28F016XS

SPECIFICATION UPDATE

Release Date: November 1996

Order Number 297553-007

Operation Delay after Power-Up and Exit from Power-Down or Reset

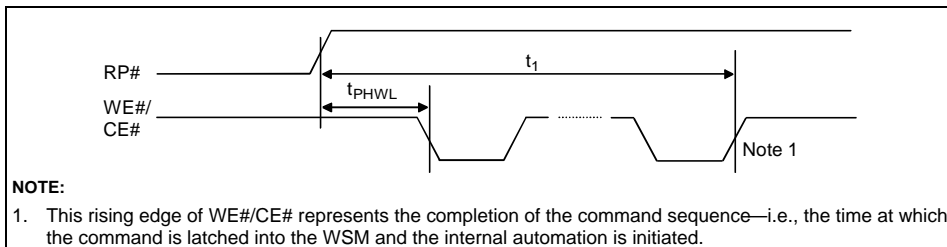
PROBLEM: With the program/erase voltage (V_{PP}) at 5V, the internal V_{PP} detector may not stabilize for up to 5 μ s (illustrated by t_1 , in the figure below) after RP# transitions inactive (high). This causes an invalid V_{PP} Level bit indication when reading the Block Status Registers and termination of program, erase or lock block operations due to invalid device V_{PP} error detection. Affected operations include Word Write (40H/10H), Block Erase (20H) and Lock Block (77H).

Note that this erratum only affects systems operating at 5V V_{PP} .

WORKAROUND: Upon reset, power-up, or wake-up from software sleep or hardware deep power-down, allow 5 μ s (t_1) before initiating a Write/Erase command (as listed earlier) or reading the V_{PP} Level bit of the Block Status Registers (BSR.1). The figure, *Operation Delay after Power-Up and Exit from Power-Down or Reset*, illustrates this timing requirement (t_1) in more detail.

Operations are initiated by the device on the rising (trailing) edge of the last WE#/CE# pulse in the command sequence. For example, when performing WE#-Controlled Writes, two-cycle command operations such as word/byte write or erase are initiated on the rising edge of the WE# pulse corresponding to the Address/Data or Confirm command. Similarly, when performing CE#-Controlled Writes, operations are initiated on the last rising CE# edge of the command sequence.

**Example System Software Flowchart That Will Not Encounter
“Completion with Command Error” Condition**

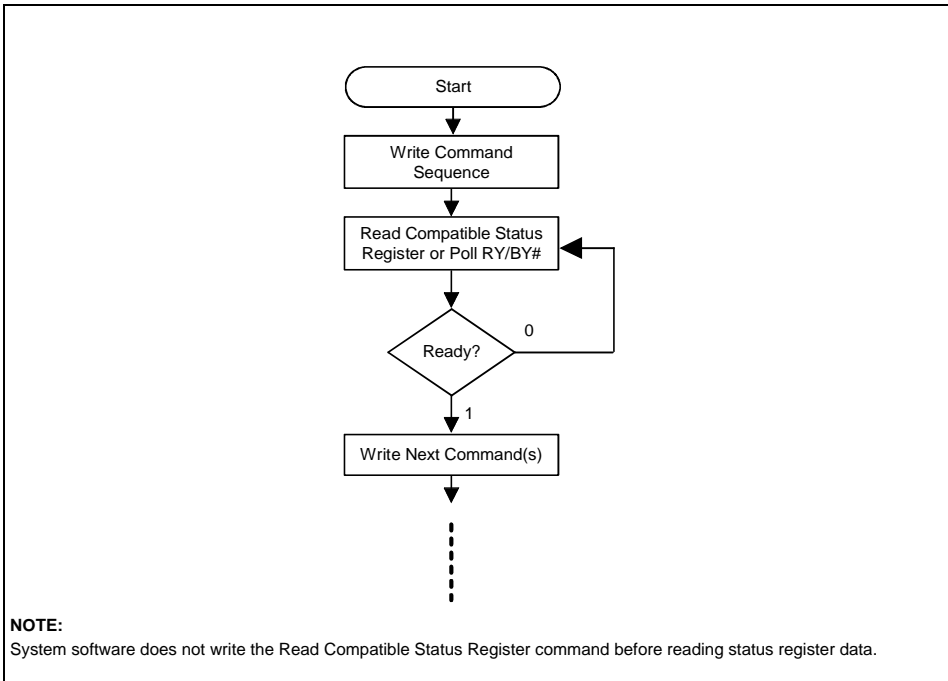
PROBLEM: Systems in which software, after initiating device automation, writes another command(s) to the device before automation completes may initiate unintended device operations.

Systems that poll the RY/BY# pin or WSMS bit (CSR.7) for “Ready” indication before writing another command to the device will not encounter this erratum. This is illustrated in the *Example System Software Flowchart*, etc. figure below, and in flowcharts 11-1 and 11-2 (without erase suspend) of the *16-Mbit Flash Memory Product Family User’s Manual*.

Timing Waveform Showing Specification Ranges That Will Not Cause the “Completion with Command Error” Condition

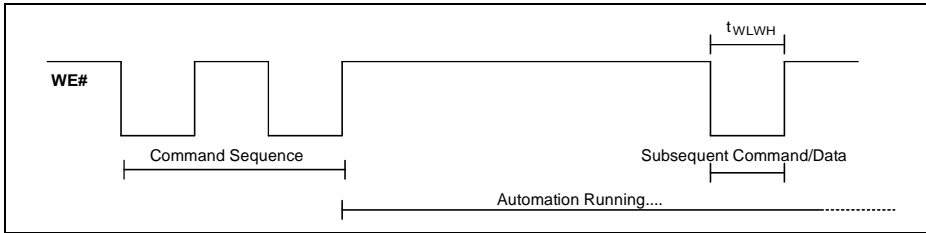
For WE#–Controlled Write Operations, a WE# pulse width defined by the ranges of parameter t_{WLWH} , in the table below, will result in a system that does not exhibit this erratum. (Note: timings are also bounded by specifications in the device datasheet). When performing CE#–Controlled Write Operations, this restriction equally applies to the CE# pulse width (t_{ELEH}).

V _{CC} Supply Voltage	t_{WLWH}	t_{ELEH}
5V	<75 ns	<75 ns
3.3V	<100 ns	<100 ns

Erase Suspend to Read Array with Compatible Status Register

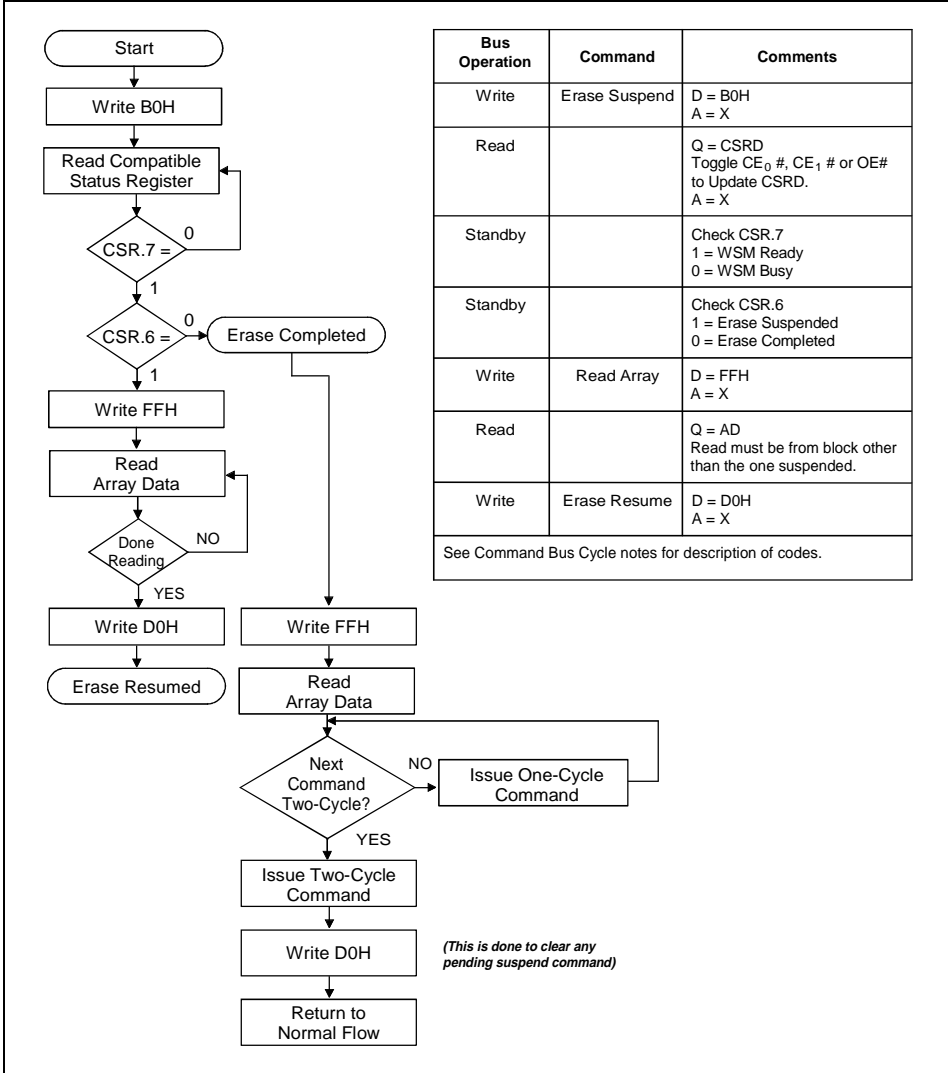
PROBLEM: If an Erase Suspend command is issued late in the Erase algorithm, it will not be recognized by 28F016XS components listed in the Affected Devices section, and erase will complete. This Erase Suspend command will **not** be discarded.

- A. If another Erase command is issued at some time later, the device then assumes that the pending Suspend request is still valid and will automatically Suspend the current Erase.
- B. If any queueable command is in the command queue waiting for execution while another queueable command is in progress, the Write State Machine will suspend its operation after completing the current command. (Refer to the *16-Mbit Flash Product Family User's Manual*, Section 11-1 for the queueable command list.)

WORKAROUND: A software workaround to this erratum inserts a redundant Resume command (D0H) immediately following any Two-Cycle Command (Word Write, Block Erase, Lock Block, or Upload Status Bits) in the Erase Suspend flowcharts. Modified Erase Suspend to Read Array flowcharts (Figures 11-3 and 11-12 of the *16-Mbit Flash Memory Product Family User's Manual*) detailing this workaround are shown in the *Erase Suspend to Read Array with Compatible Status Register* and *Erase Suspend to Read Array with Extended Status Register* figures, which follow. This erratum results in the *Erase Suspend with Compatible Status Register* flowchart being incompatible with the 28F008SA *Erase Suspend* flowchart.

Read Timing Waveform (SFI Configuration = 2, Alternate-Bank Access)

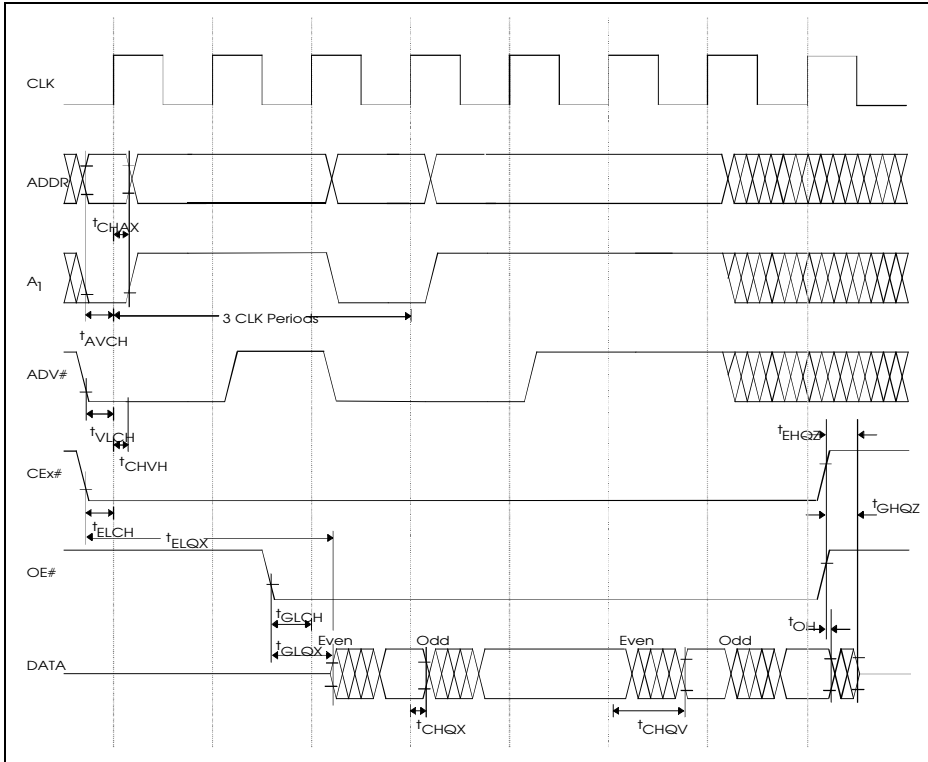
PROBLEM: An additional wait-state is required between consecutive Same-A₁ accesses for components listed in the Affected Products section.

The Read Timing Waveform, which follows, illustrates a modified version of the read timing waveform, Figure 11 in the *28F016XS 16-Mbit (1 Mbit x 16, 2 Mbit x 8) Synchronous Flash Memory Datasheet*, which illustrates this burst access sequence described in the previous paragraph. Similarly, this condition applies to all SFI Configurations.

WORKAROUND: A new Same-A₁ (same bank) address cannot be placed on the bus until after the rising clock edge upon which data for the previous Same-A₁ (same bank) access is driven out of the 28F016XS flash memory device. This rising CLK edge will occur a number of clock cycles equal to the SFI Configuration setting after latching the address from the previous Same-A₁ access. Addresses are latched upon sensing ADV# low in conjunction with a rising CLK edge.
